### SITE/SOIL EVALUATION FOR ON-SITE WASTE WATER

SURVEY FOR:		BENNETT SURVEYS, INC.	
PROPOSED PLOT PLAN - LOT - 126		1662 CLARK RD., LILLINGTON, N.C. 27546	
WOODSHIRE S/D, PHASE FOUR		(910) 893-5252	
TOWNSHIP ANDERSON CREEK	COUNTY HARNETT	20 0 40	SURVEYED BY: FIELD BOO

# FAX COVER SHEET

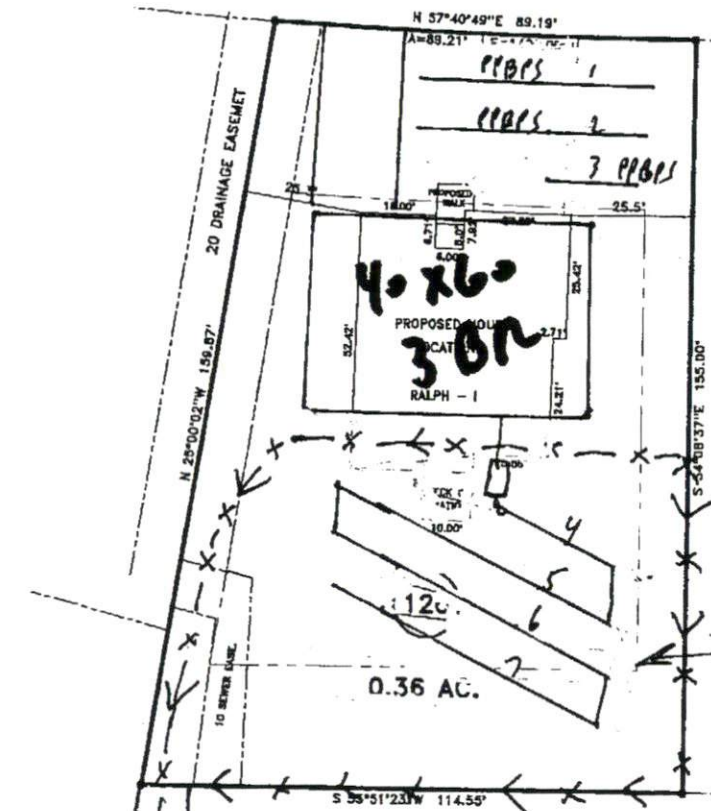
210 LF. 25% reduction @ 0.5 gpd/ft

X-X = French drain at 3.5 feet

Establish permanent drainage easement to outlet

French drain around initial as shown. Let me know before I notify A+H of changes.  
 50% increase in LTAR

INITIAL = 1 x 180' (use 1 x 215' 25% reduction)  
 Repair = 1 x 120' ~~ETAR~~ PPRS @ 0.5  
 or 1 x 160' with pretreat @ 0.75

Proposal for 12c Woodbine  
 Limit to 3 BR 40 x 60' as shown  
 LTAR = 0.5 gpd/ft<sup>2</sup> INITIAL + REPAIR
